Docket Item #8
BAR CASE #2008-0052

ISSUE: Re-approval for a New residential building

LOCATION: 804 Pendleton Street

UPDATE: The applicant is requesting a re-approval of previously approved plans and a Certificate of Appropriateness for the construction of a single-family house at 804 Pendleton Street, approved last year by the Board at the April 25, 2007 public hearing. The applicant was unable to commence the project within the one-year time frame of the approval. The scope of the project has not changed from what the Board approved on April 25, 2007. Therefore, Staff repeats the recommendation of approval with the archaeological conditions as stated.

Figure 2 -
Proposed plan

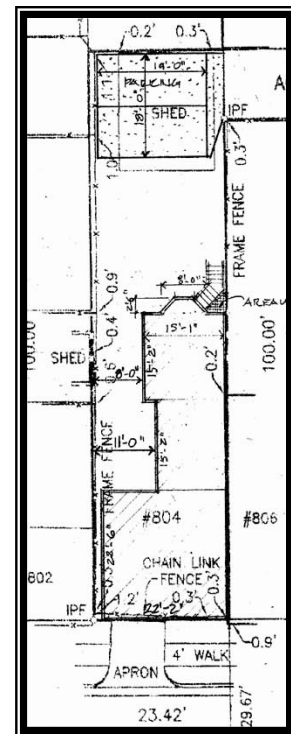
The proposed house will be composed of three sections. The front block is square in plan. It will abut the house at 806 Pendleton Street on the west side and extend across nearly the entire width of the lot and leaving 11" between the wall and the property line on the east side. The narrower middle section will be rectangular in plan. It will also abut the house at 806 Pendleton Street on the west side and will be set back 11' from the east property line. The rear section is wider than the middle section and square in plan. It will be set back 8' from the east property line and will extend beyond the house at 806 Pendleton Street on the west side. The house will be 55'4" long. The height of the house will be 24'10" high at the front block and will step down in height thrice with the middle section being approximately 24'1", the rear section proposed to be 23'4", and the rear bay 22'10". The house will be two stories with a raised basement and a flat roof. It will be constructed of CMU. The main block of the house will be clad in brick on the north

Figure 3 – Proposed front (north) elevation

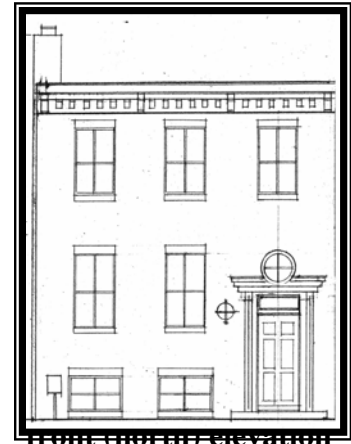
The front (north) elevation will appear as a two story house with a full flat roof and raised basement. The front door will be on the right side of the elevation at street level. The door will be a four-panel door as shown on the detail sheet, rather than six panel. It will be set within a heavy door surround with a rectangular transom and an oculus window above. A globe shaped, surface mounted light fixture will be located to the left of the door. A single step brick stoop will lead to the door. There will be two, four-light windows to the left of the door lighting the basement level, which will be partially below grade. As revised, the basement windows will be at grade and will not have window wells. The first story will have two, two-over-two windows to the left of the door. These windows will be approximately 5.5' in height. The window height will be slightly less in the second story where there will be three evenly spaced two-over-two windows. There will be a wood cornice with brackets and dentils at the base of the flat roof. The cornice will extend around all but the west elevation. There will be a gutter across the front and downspouts at either corner. The electrical meter will be located just above grade at the left side of the front elevation.

Figure 4 – Proposed side (west) elevation

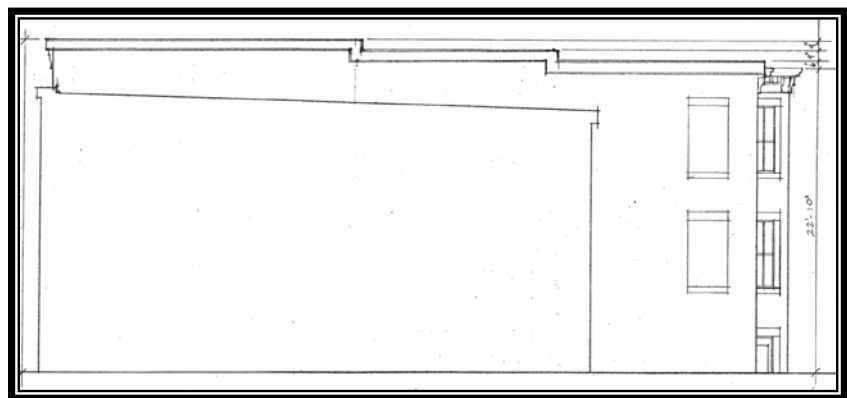
The 55'4" long west elevation will be partially obscured by the adjacent houses at 806 and 808 Pendleton Street. The rear 15' of the proposed house will extend beyond the neighboring houses at 806 and 808 Pendleton Street and will be visible in oblique views from Pendleton Street and the alley. It may also be partially visible from Alfred Street. The narrow sliver of wall visible above 806 Pendleton Street will be clad in metal flashing to ensure

that the joint between the new and existing house is watertight. The back section of the proposed house that extends beyond 806 and 808 Pendleton Street will be covered in stucco. There will be two rectangular areas inset approximately 1" to suggest blind windows at the south end of this section on the first and second stories. The inset areas will have sills and headers and will be stuccoed.
